From: Ashley Lindsay <Ashley.Lindsay@clarence.nsw.gov.au>
Sent: Monday, March 15, 2021 4:02 PM
To: Lynne Cairns <blcairns@bigpond.com>
Cc: Jim Simmons <Jim.Simmons@clarence.nsw.gov.au>; Debrah Novak <Debrah.Novak@clarence.nsw.gov.au>; 'spowelly POWELL' <spowelly@bigpond.com>; Lesley McBay <Lesley.McBay@clarence.nsw.gov.au>; Des Schroder <Des.Schroder@clarence.nsw.gov.au>; Adam Cameron <Adam.Cameron@clarence.nsw.gov.au>
Subject: RE: Request for a Meeting with General Manager, Mayor, Cr Novak, Mr Powell and Mr and Mrs Cairns

RE: DA2019/0439, MOD2021/0016 and DA2021/0153
19 GUMNUT ROAD YAMBA

From: Lynne Cairns
Sent: Thu, 25 Mar 2021 13:46:58 +1100
To: Council Email
Cc: 'spowelly POWELL'
Subject: First Email: Submission MOD2021/0016 and DA2021/0153
Attachments: Attachment 1 Front page_Summary.pdf, Attachment 2 Detailed information.pdf, Attachment 3 Photos.pdf, Attachment 4 Issues and breaches DA2019_0439 Conditions of Consent.pdf, Attachment 5 Details and signatures of those making Submission.pdf, Attachment 6 DA2019-0439 Notification Plan 19 Gumnut Road Yamba.pdf, Attachment 7 DA 2019-0439 Application DA assessment.pdf, Attachment 8 ECM_1996721_v1_DAP memo 19 Gumnut Rd Yamba DA2019

1. Photo taken 24 November 2020 of deck at 19 Gumnut Road Yamba sitting on non-complying foundations (the retaining wall) and non-complying deck is out over the revetment wall – Council neglected to locate revetment wall in accordance with Councils DCP Schedule C2 page 47, points 4 and 5.

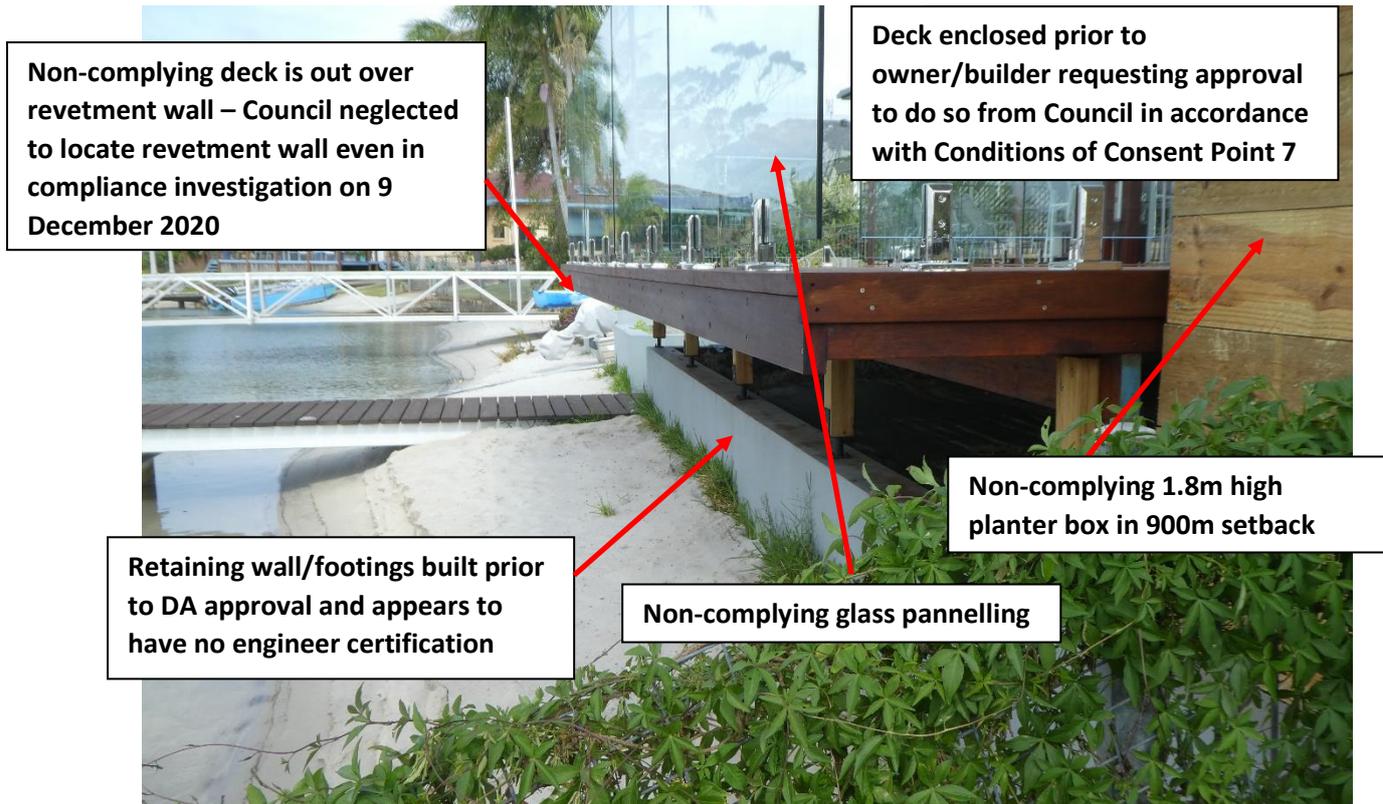
2. Photo of deck at 19 Gumnut Road Yamba sitting on footings (the retaining wall) taken 24 November 2020 – non complying downpipe, deck, footings, and overflow pipe

5. Photo taken 6 August 2020 19 Gumnut Road – installing extended roof on studio – non complying retaining wall/foundations visible for deck constructed prior to DA approval

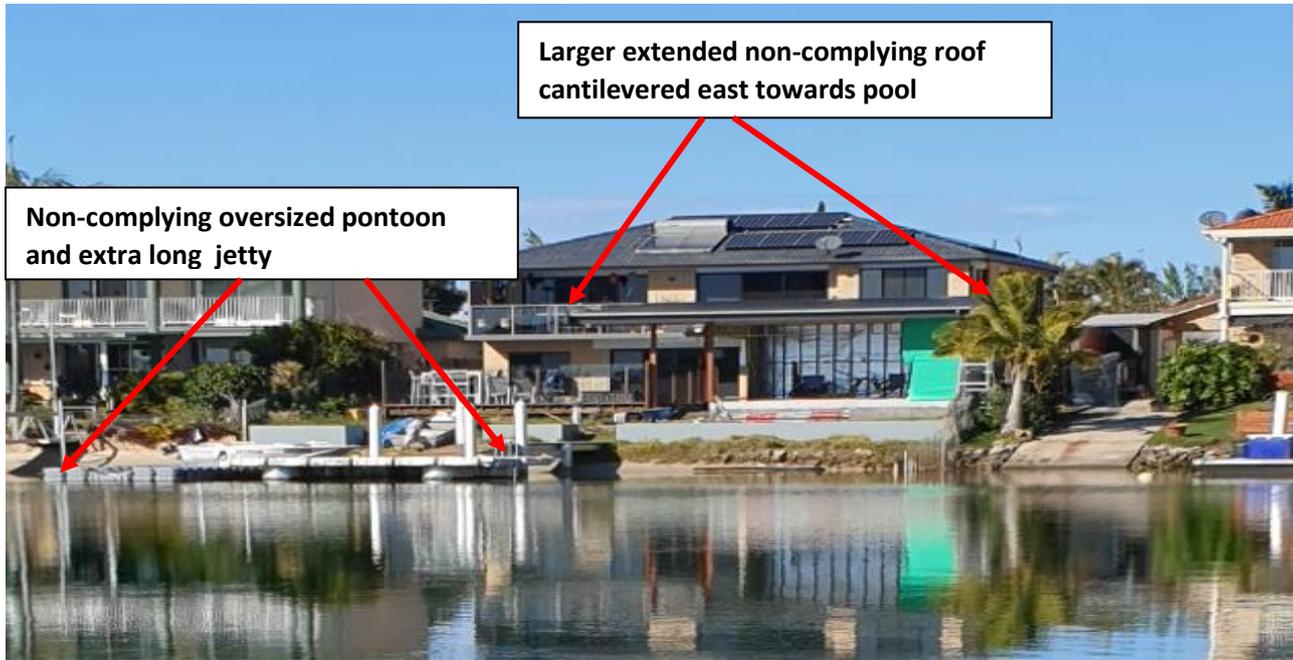
6. Photo taken 16 August 2020 19 Gumnut Road – extended non-complying roof complete on studio - no downpipe visible

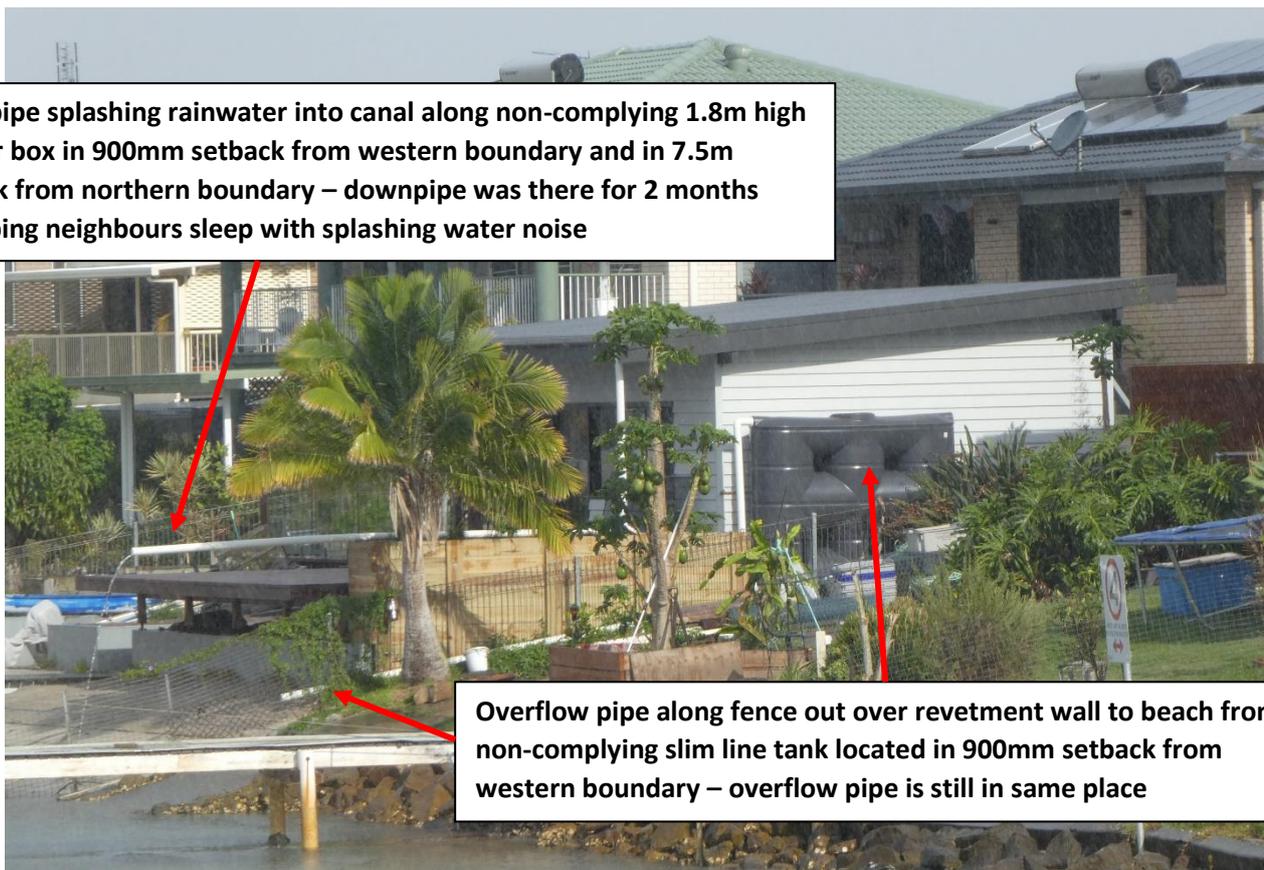
Downpipe splashing rainwater into canal along non-complying 1.8m high planter box in 900mm setback from western boundary and in 7.5m setback from northern boundary – downpipe was there for 2 months disturbing neighbours sleep with splashing water noise

Overflow pipe along fence out over revetment wall to beach from non-complying slim line tank located in 900mm setback from western boundary – overflow pipe is still in same place

10. Photo taken 1 December 2020 19 Gumnut Road – downpipe and tank overflow still in place, non-complying glass panelling installed to deck. Non-complying roof larger than in Consent Plans and cantilevered to east, and Structural Plans show roof as a hip roof not flat

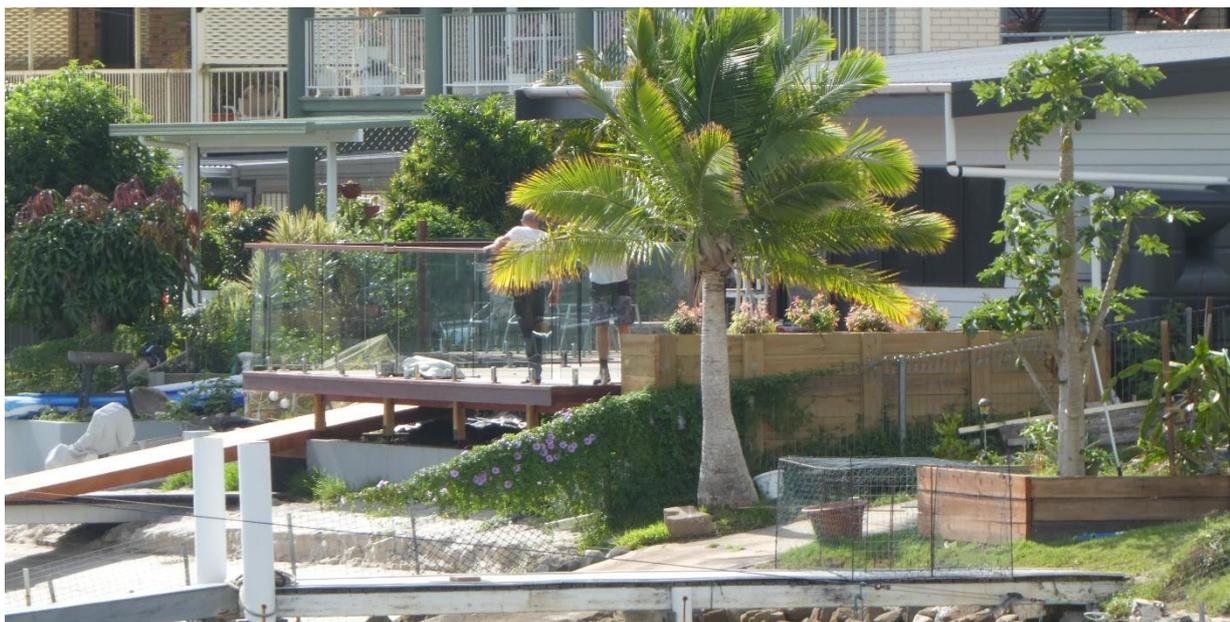
Larger extended non-complying roof cantilevered east towards pool

Downpipe along non-complying planter box and tank overflow on beach north of revetment wall

15. Photo taken 30 September 2018 of 19 Gumnut Road – outer extents of jetty demolished and removed back to first tall piers from the beachfront and pontoon being constructed on beachfront of 19 Gumnut Road. No retaining wall/footings constructed.

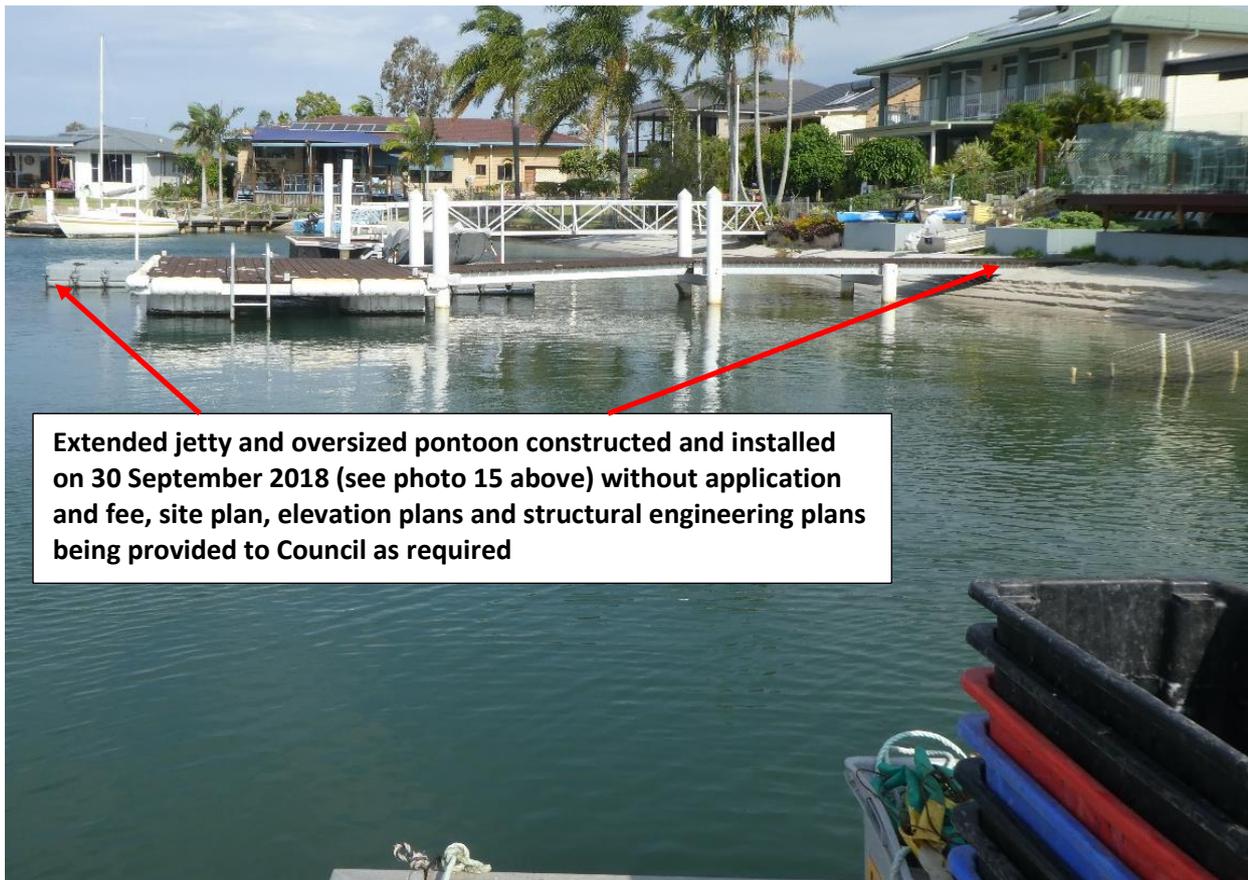
16. Photo taken 23 September 2019 showing retaining wall/footings already built prior to DA approval on 25 November 2019

Extended jetty and oversized pontoon constructed and installed on 30 September 2018 (see photo 15 above) without application and fee, site plan, elevation plans and structural engineering plans being provided to Council as required

22 a). Photo taken 29 October 2019 – backyard of 19 Gumnut Road Yamba – excavator filling behind already constructed retaining wall prior to DA2019/0439 approval

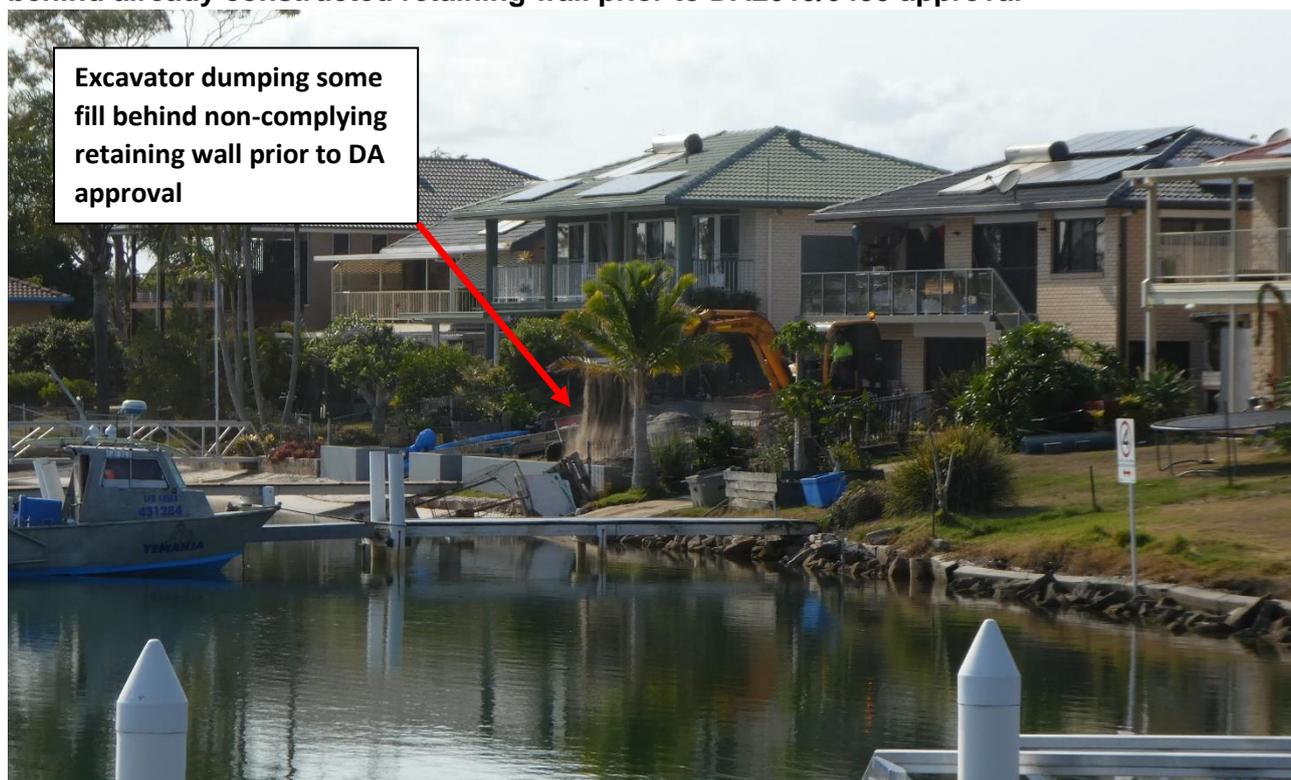
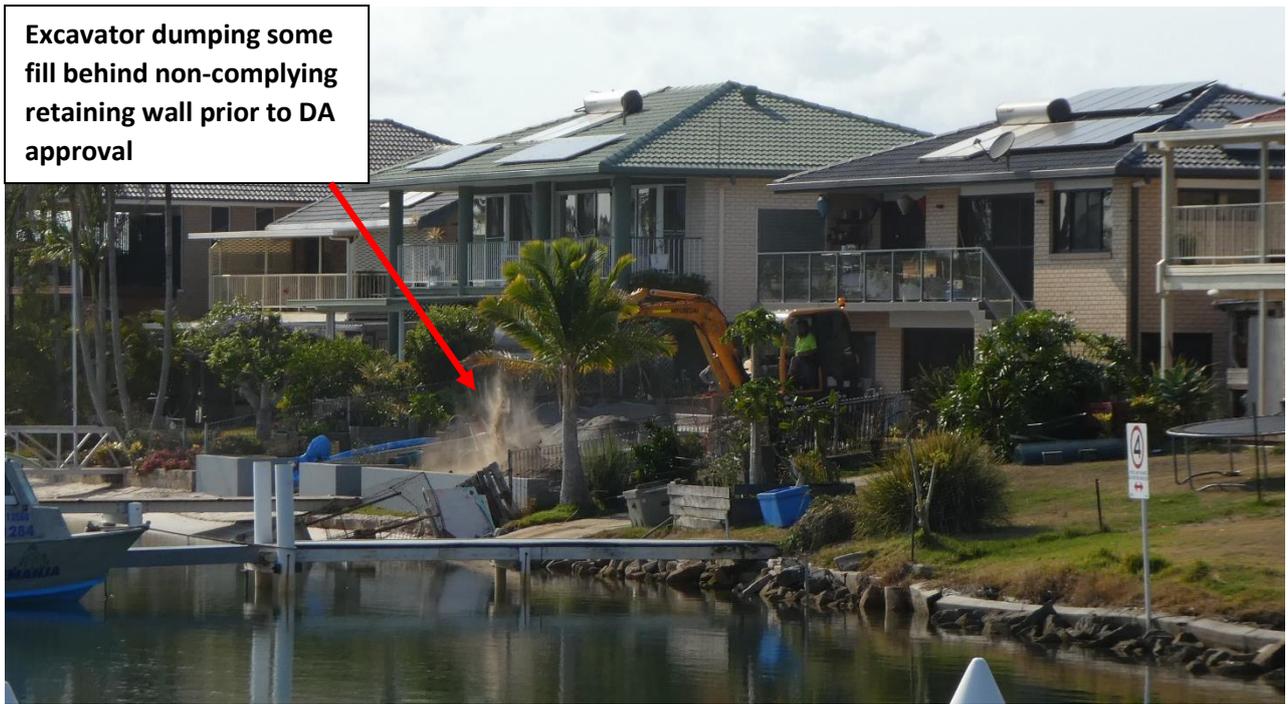
22 b). Photo taken 29 October 2019 – backyard of 19 Gumnut Road Yamba – excavator filling behind already constructed retaining wall prior to DA2019/0439 approval

Excavator dumping some fill behind non-complying retaining wall prior to DA approval

Non-complying 1.8m high planter box in 900mm setback and 7.5m setback from canal

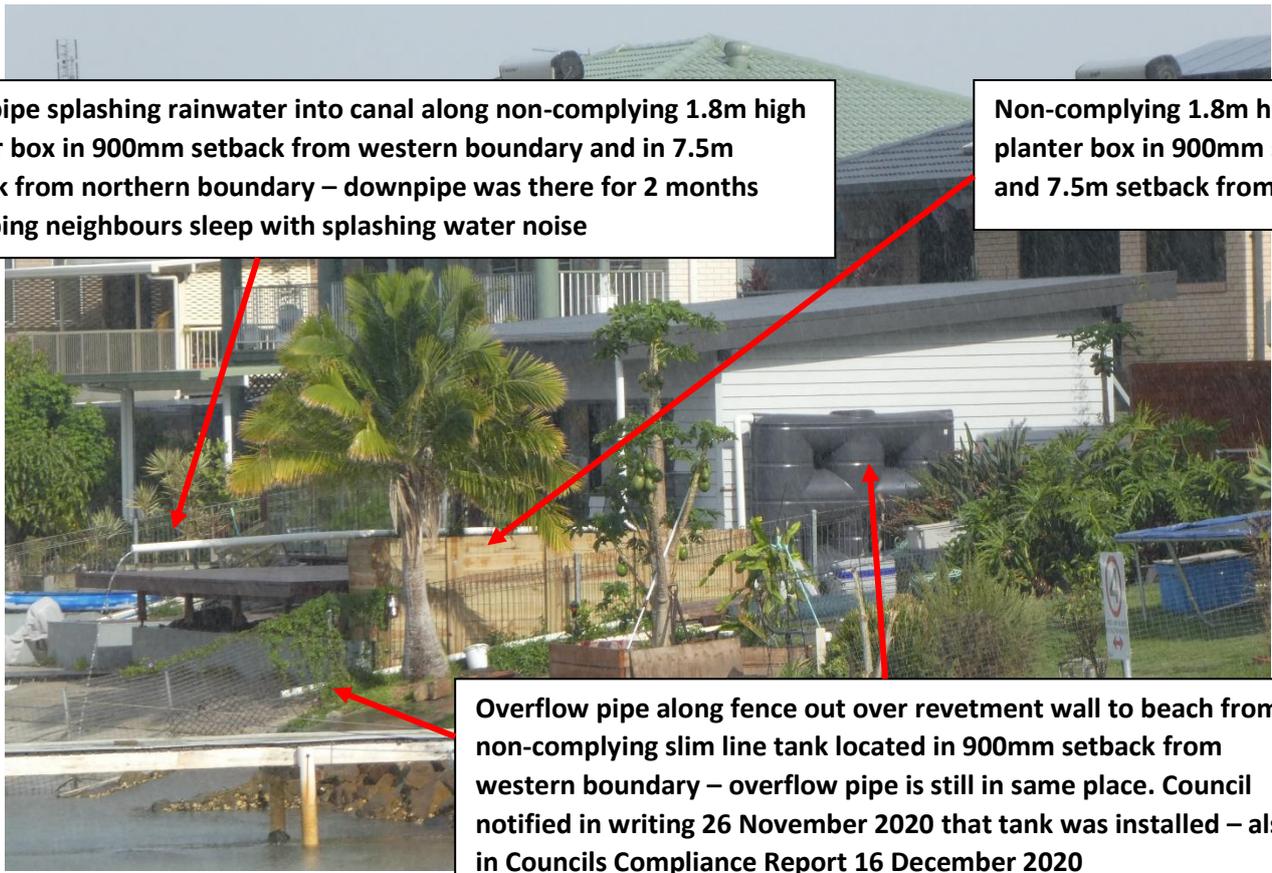
Overflow pipe along fence out over revetment wall to beach from non-complying slim line tank located in 900mm setback from western boundary – overflow pipe is still in same place. Council notified in writing 26 November 2020 that tank was installed – also in Councils Compliance Report 16 December 2020

Large non-complying extendable awning (installed 28 Jan 2021 – Council emailed 31 January 2021) - out over non-complying deck awning

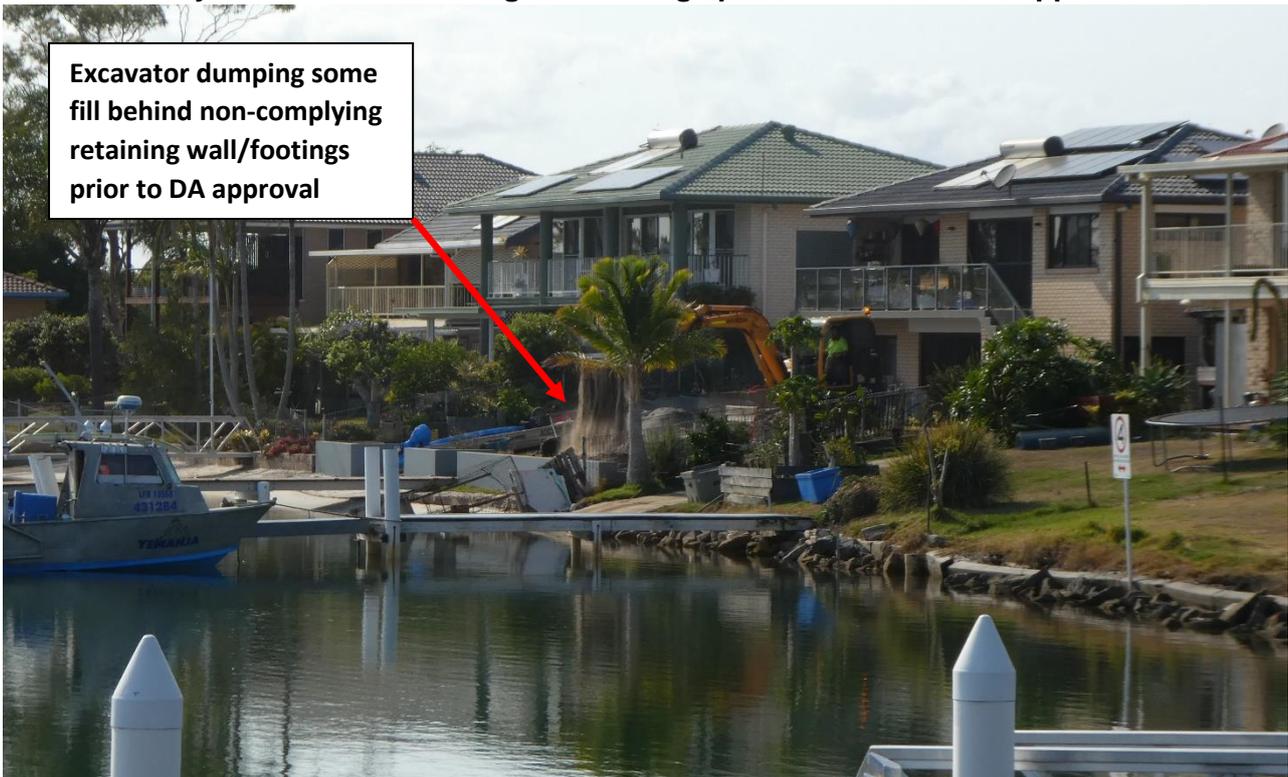
Non-complying glass panelling with wooden bar on top
